Access Compliance Report Public Rights-of-Way (Curb Ramps)

Intersection ID: 10027975 Main Street: HARLEE AV **Cross Street: N/A** Location: S **ADA ID: 2E6F9BBCF419** Ramp Type: PerpDiag Initial Pass/Fail: Fail **Overall Compliance: No Severity Score:** 25

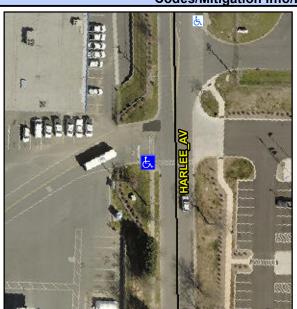
Possible Solutions: Remove & Replace Curb Ramp With Two New Directional Ramps or Equivalent. Surveyor Notes: N/A PROW/ADA: Not Found, R304.5.3

Field Measurements/Component Compliance					
Compliance Description		Data	Comp	liance Description	Data
N/A	Ramp Length (in)	59.0	Yes	Ramp Slope (%)	8.3
Yes	Ramp Width (in)	48.0	No	Ramp XSlope (%)	7.9
N/A	Flare Type LT	N/A	N/A	Flare Type RT	N/A
N/A	Flare Slope LT (%)	N/A	N/A	Flare Slope RT (%)	N/A
N/A	Flare Traversable LT?	N/A	N/A	Flare Traversable RT?	N/A
N/A	Landing Length (in)	N/A	N/A	DWS Provided?	N/A
N/A	Landing Width (in)	N/A	N/A	DWS Contrast?	N/A
N/A	Landing Slope (%)	N/A	N/A	DWS Length (in)	N/A
N/A	Landing X Slope (%)	N/A	N/A	DWS Full Width?	N/A
N/A	Landing Curb? (Y/N)	N/A	N/A	DWS Offset (in)	N/A
N/A	Shared Landing?	N/A			
N/A	Gutter Ponding?	N/A	N/A	Gutter Slope (%)	N/A
N/A	Gutter Lip Ht (in)	N/A	N/A	Gutter X Slope (%)	N/A
N/A	Painted X Walk1?	No	N/A	Painted X Walk2?	No
	X Walk 1 Direction	То Е		X Walk 2 Direction	To N
N/A	X Walk 1 Width (in)	N/A	N/A	X Walk 2 Width (in)	N/A
	X Walk 1 Slope (%)	5.5		X Walk 2 Slope (%)	1.4
